Subject: **Request for Modification of Section 404 General Permit No. 198200031 and Section 401 Water Quality Certification, and lifting of Notice of Violation Status** for the Interstate 85 (I-85) widening and interchange improvements from north of NC 73 to north of SR 1280, Cabarrus and Rowan Counties, Divisions 9 and 10. Federal Aid Project No. NHIMF-085-2(61)55, TIP I-3802A.

The North Carolina Department of Transportation (NCDOT) requests modification to the existing General Permit No. 198200031 and associated Water Quality Certification for widening and interchange improvements along I-85 in Cabarrus and Rowan Counties. This project is currently under construction.

Revisions have been made to seventeen impact sites and are discussed in detail below. Two new impact sites are also discussed below (Site 36 and the Troutman waste site).

Permit Troutman Waste Area #1  
72 LF of 24" CSP

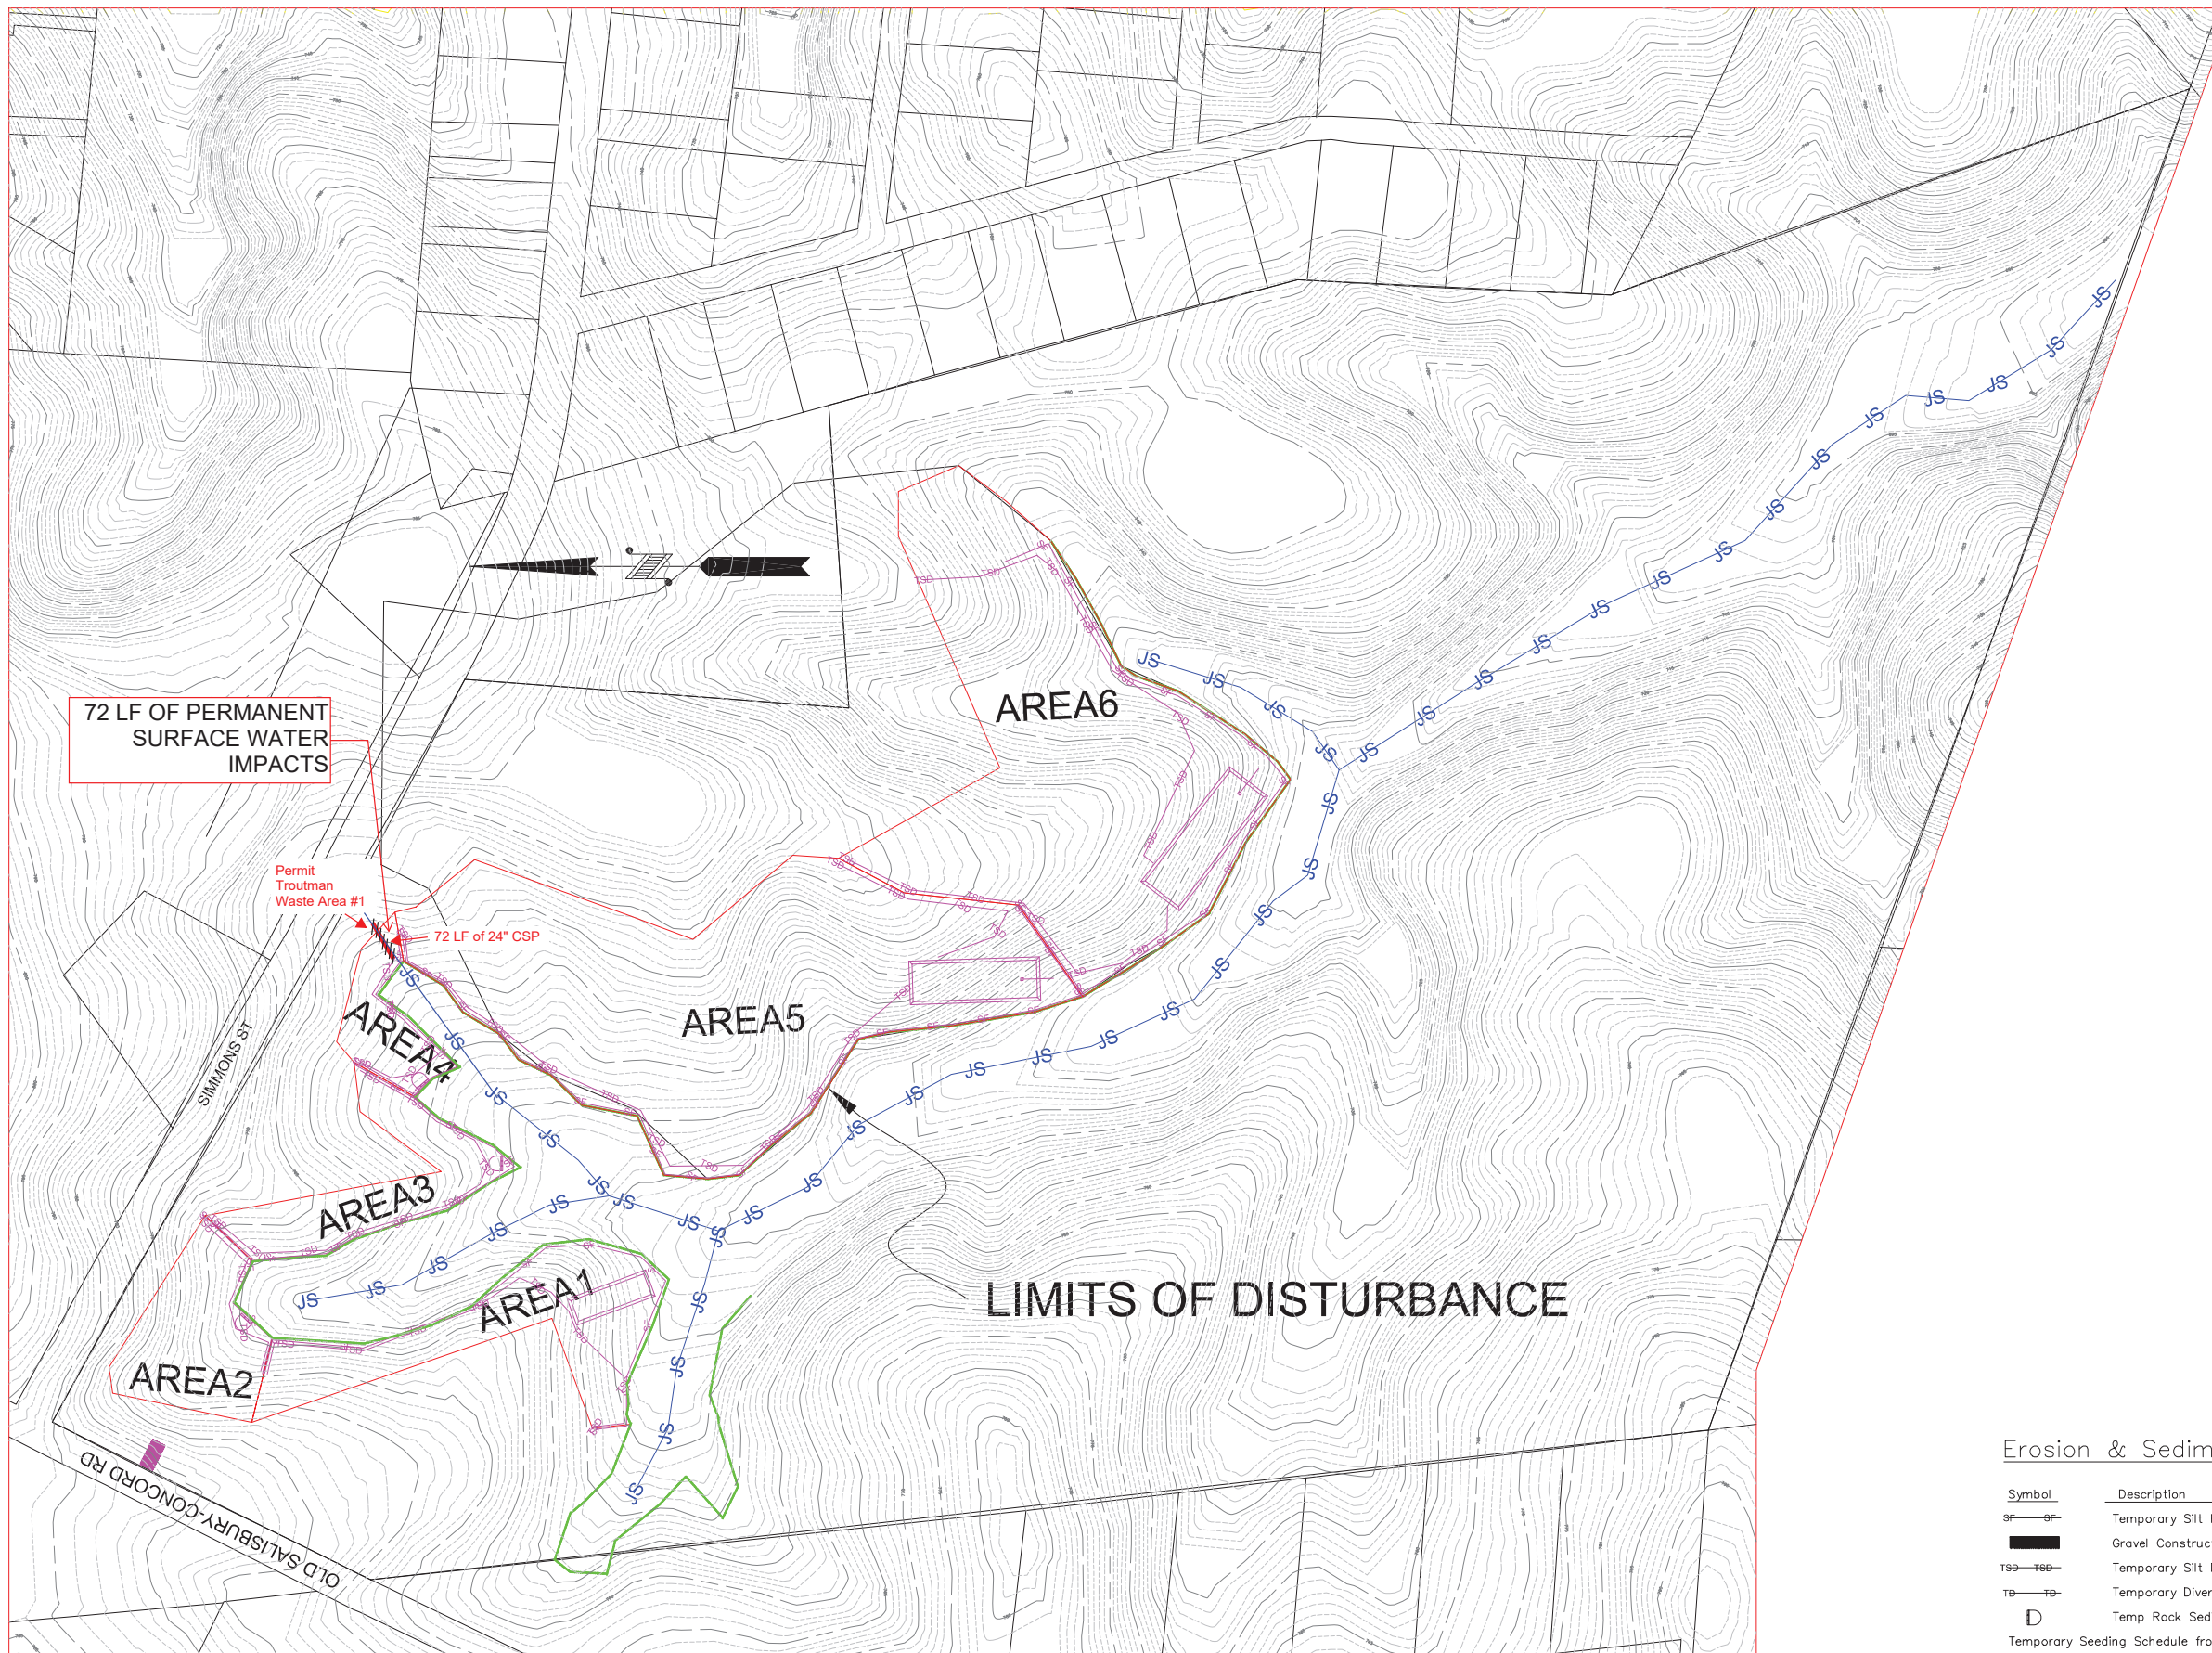
Troutman Waste Area Site 1 (Last Sheet) – The contractor inadvertently impacted a jurisdictional stream with fill. This was identified by the North Carolina Division of Water Resources (NCDWR) representative during a site visit. A 24” pipe was later installed to maintain flow in the stream. An additional 72 linear feet of permanent stream impacts were created.
